SECTION 96 MODIFICATION TO DA269/2015:

project:
LOT 74 D.P.8075
77 BOWER STREET MANLY

drawing:
ELEVATION NORTH & EAST
status :
SECTION 96 MODIFICATION TO DA269/2015

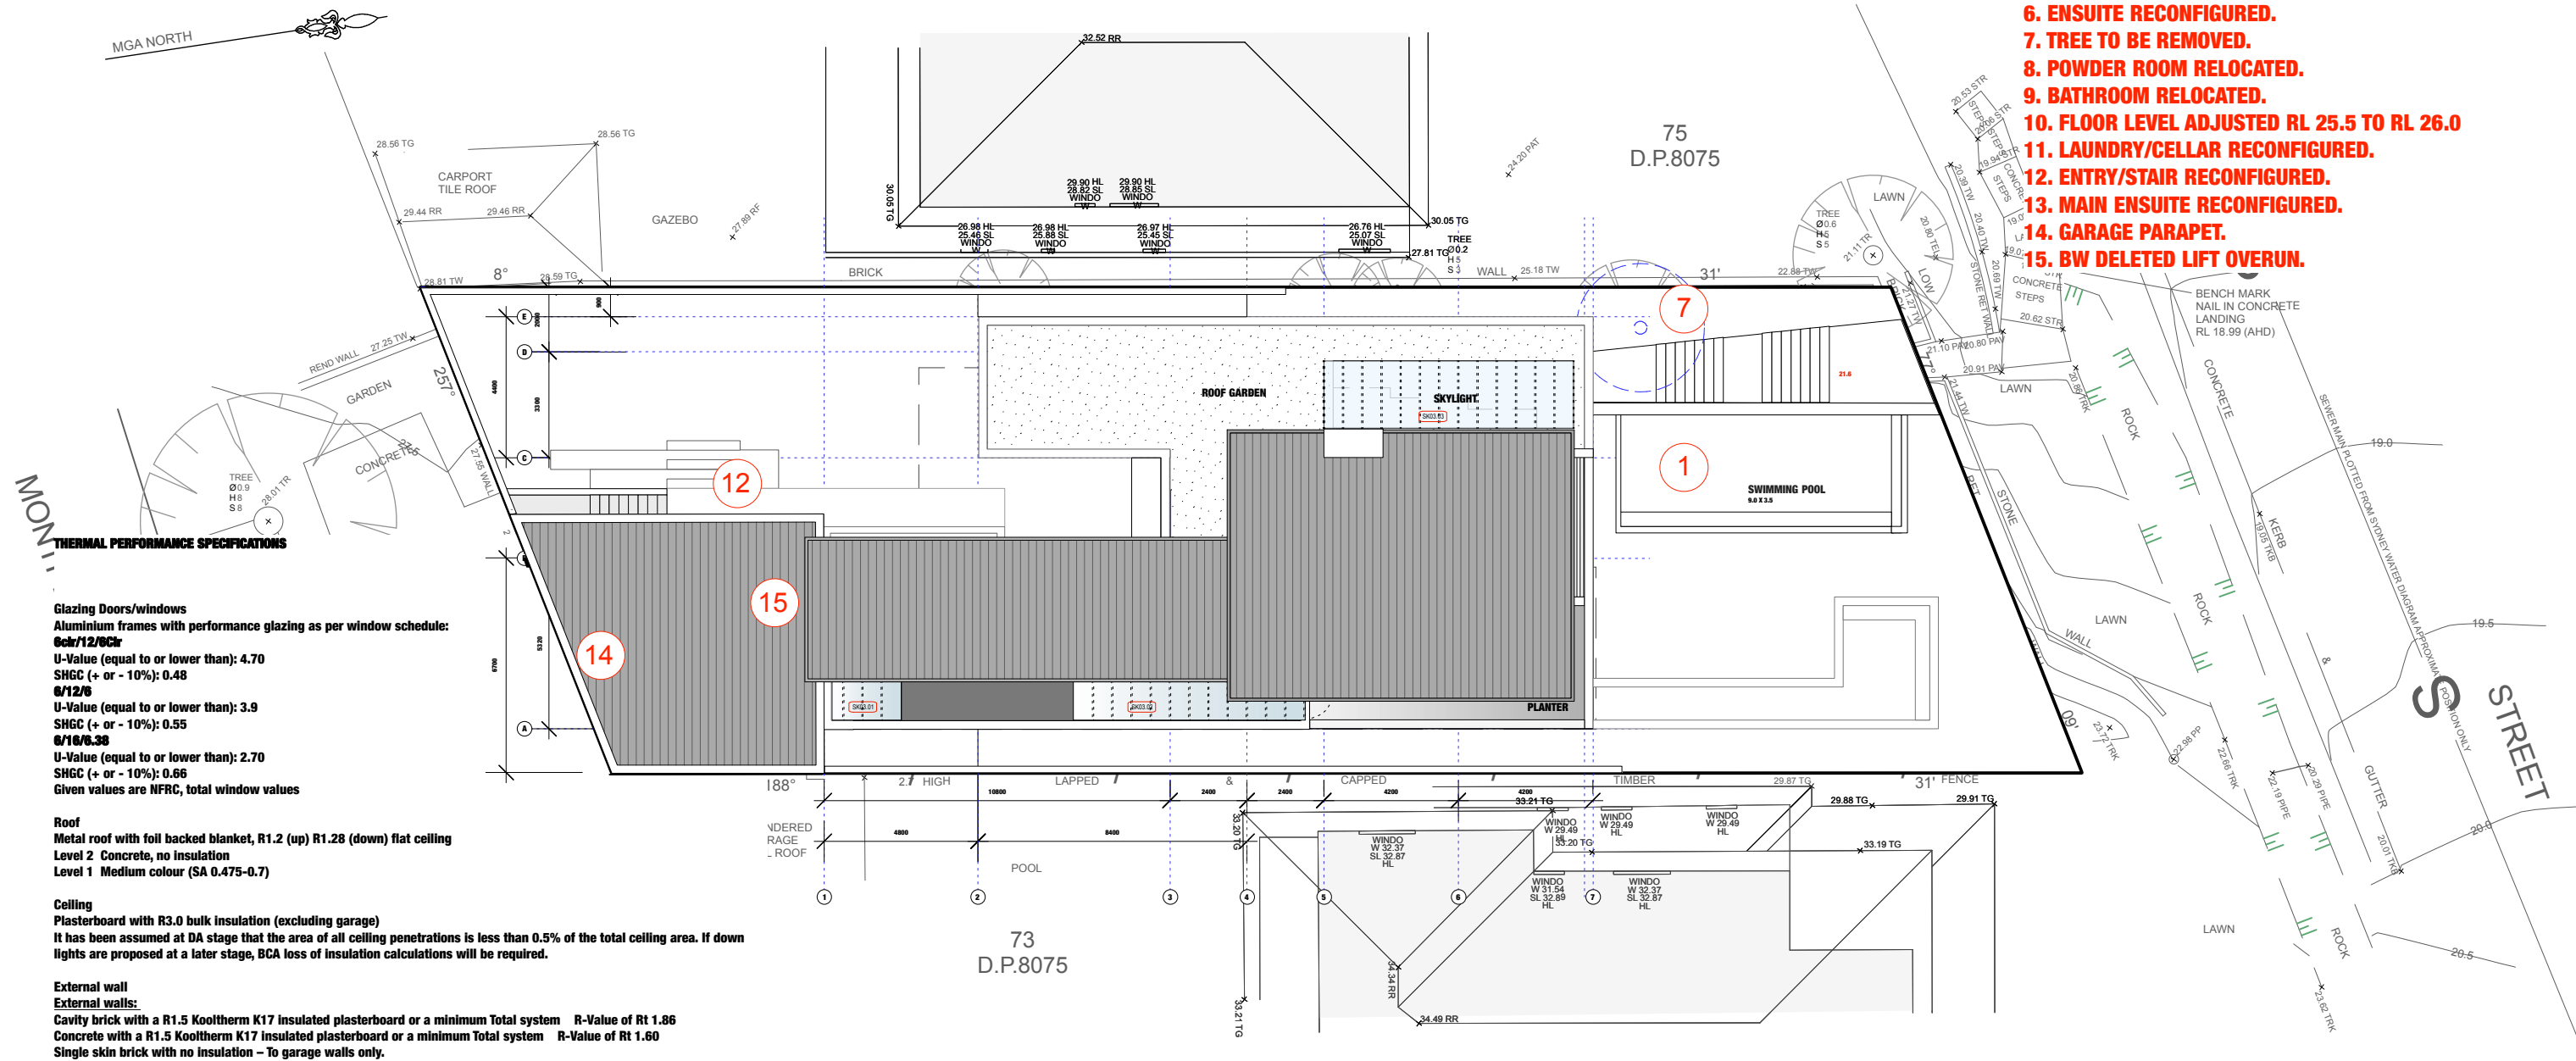
1. SWIMMING POOL ADJUSTED.
2. INTERNAL STAIR RECONFIGURED.
3. SERVICE AREA RECONFIGURED.
4. GYM RECONFIGURED.
5. LIGHTWELL/VOID.
6. ENSUITE RECONFIGURED.
7. TREE TO BE REMOVED.
8. POWDER ROOM RELOCATED.
9. BATHROOM RELOCATED.
10. FLOOR LEVEL ADJUSTED RL 25.5 TO RL 26.0
11. LAUNDRY/CELLAR RECONFIGURED.
12. ENTRY/STAIR RECONFIGURED.
13. MAIN ENSUITE RECONFIGURED.
14. GARAGE PARAPET.
15. BW DELETED LIFT OVERUN.

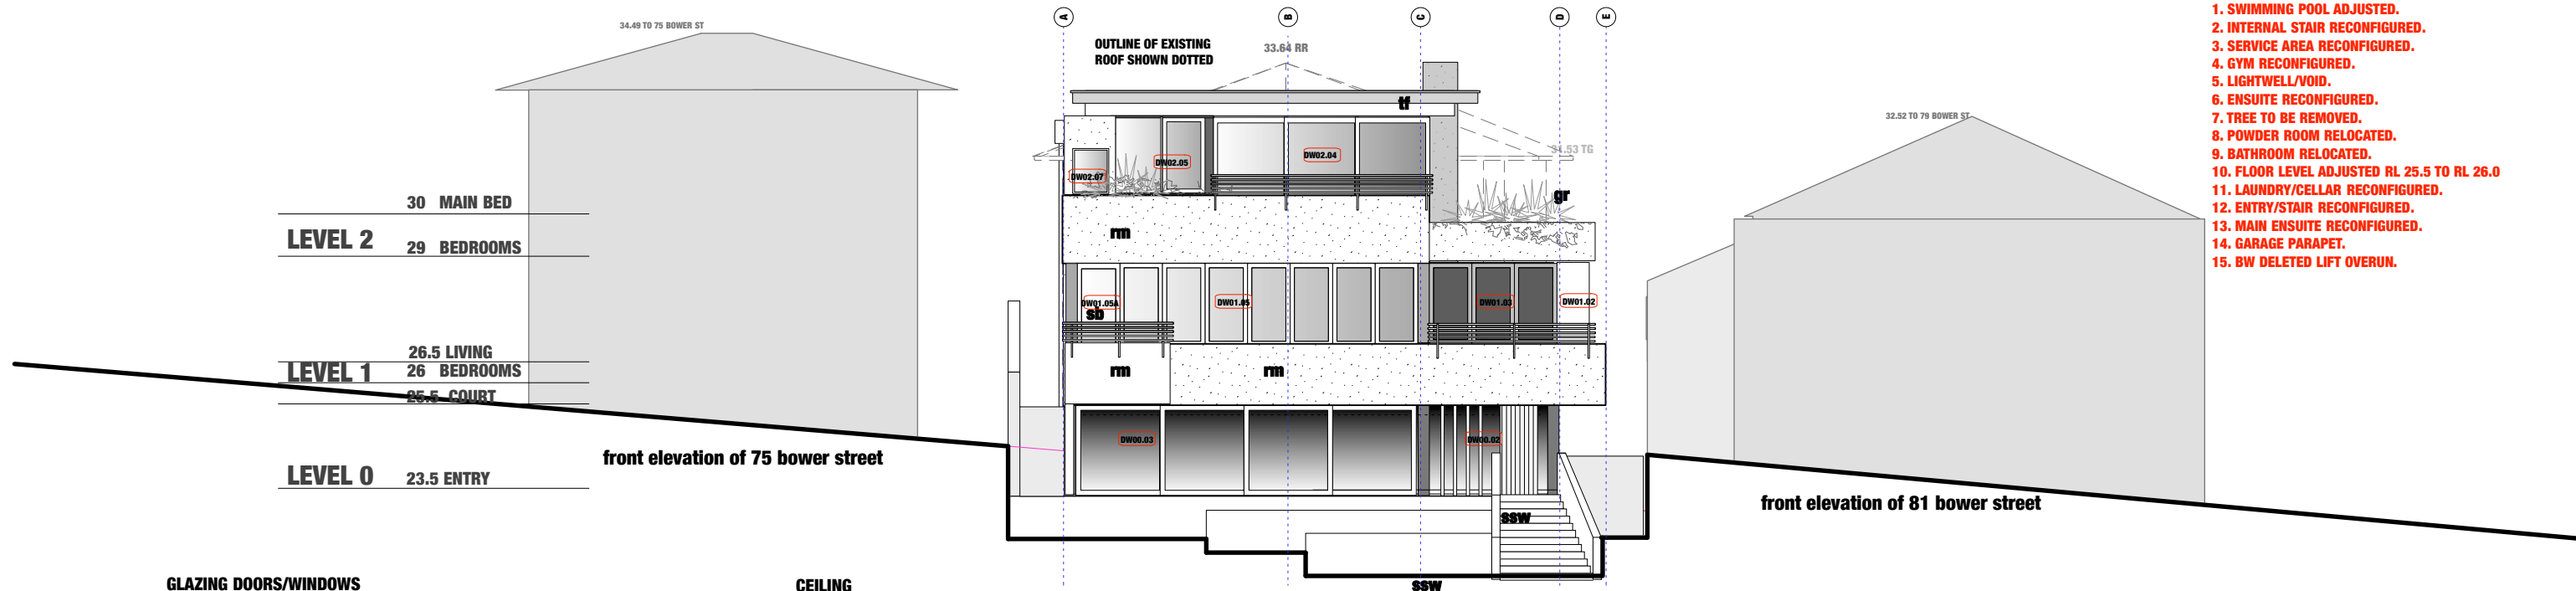
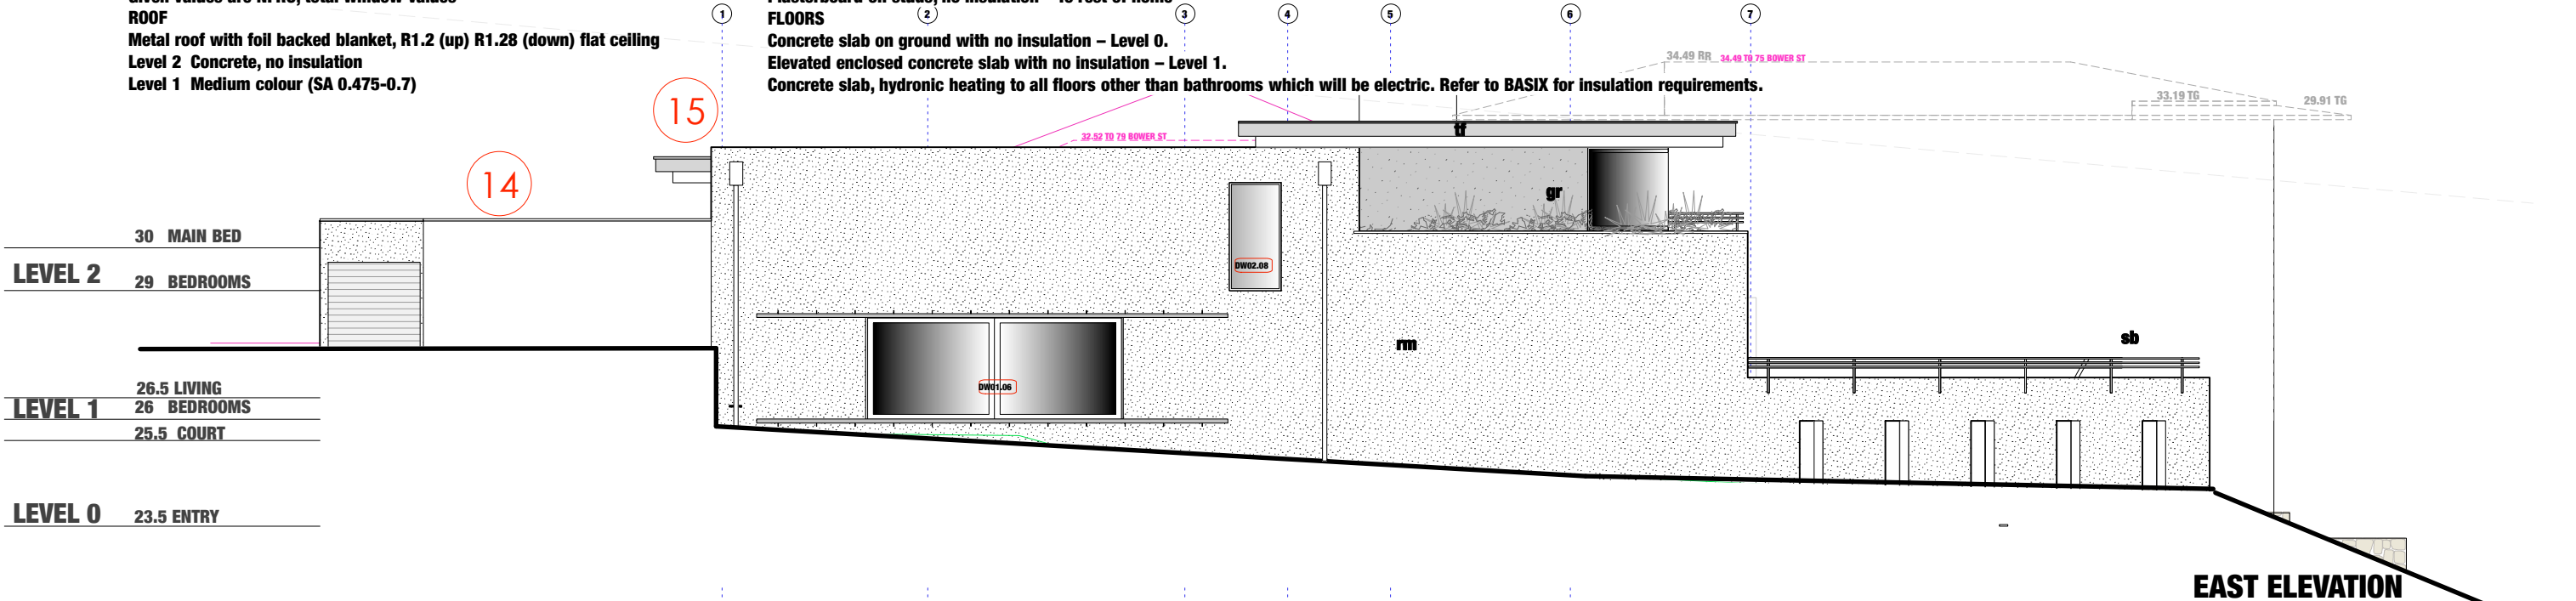
1. SWIMMING POOL ADJUSTED.
2. INTERNAL STAIR RECONFIGURED.
3. SERVICE AREA RECONFIGURED.
4. GYM RECONFIGURED.
5. LIGHTWELL/VOID.
6. ENSUITE RECONFIGURED.
7. TREE TO BE REMOVED.
8. POWDER ROOM RELOCATED.
9. BATHROOM RELOCATED.
10. FLOOR LEVEL ADJUSTED RL 25.5 TO RL 26.0
11. LAUNDRY/CELLAR RECONFIGURED.
12. ENTRY/STAIR RECONFIGURED.
13. MAIN ENSUITE RECONFIGURED.
14. GARAGE PARAPET.
15. BW DELETED LIFT OVERUN.

SOUTH ELEVATION

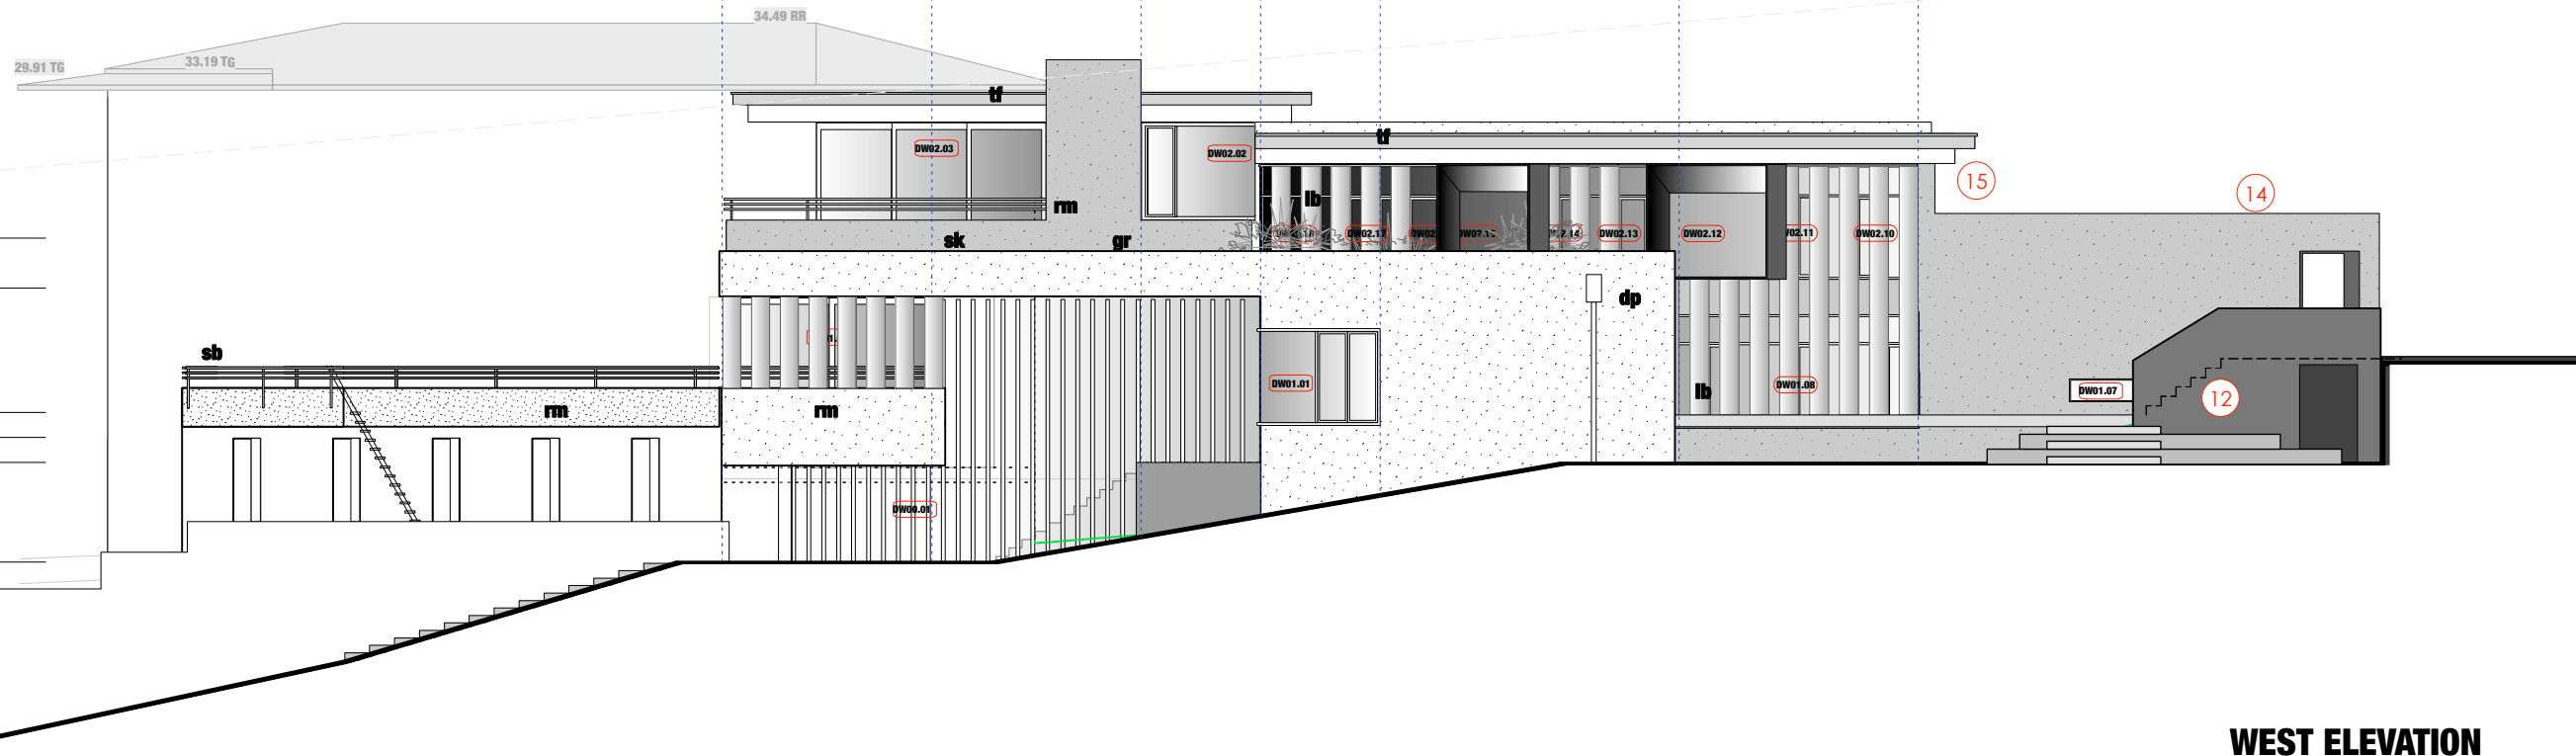
1. SWIMMING POOL ADJUSTED.
2. INTERNAL STAIR RECONFIGURED.
3. SERVICE AREA RECONFIGURED.
4. GYM RECONFIGURED.
5. LIGHTWELL/VOID.
6. ENSUITE RECONFIGURED.
7. TREE TO BE REMOVED.
8. POWDER ROOM RELOCATED.
9. BATHROOM RELOCATED.
10. FLOOR LEVEL ADJUSTED RL 25.5 TO RL 26.0
11. LAUNDRY/CELLAR RECONFIGURED.
12. ENTRY/STAIR RECONFIGURED.
13. MAIN ENSUITE RECONFIGURED.
14. GARAGE PARAPET.
15. BW DELETED LIFT OVERUN.
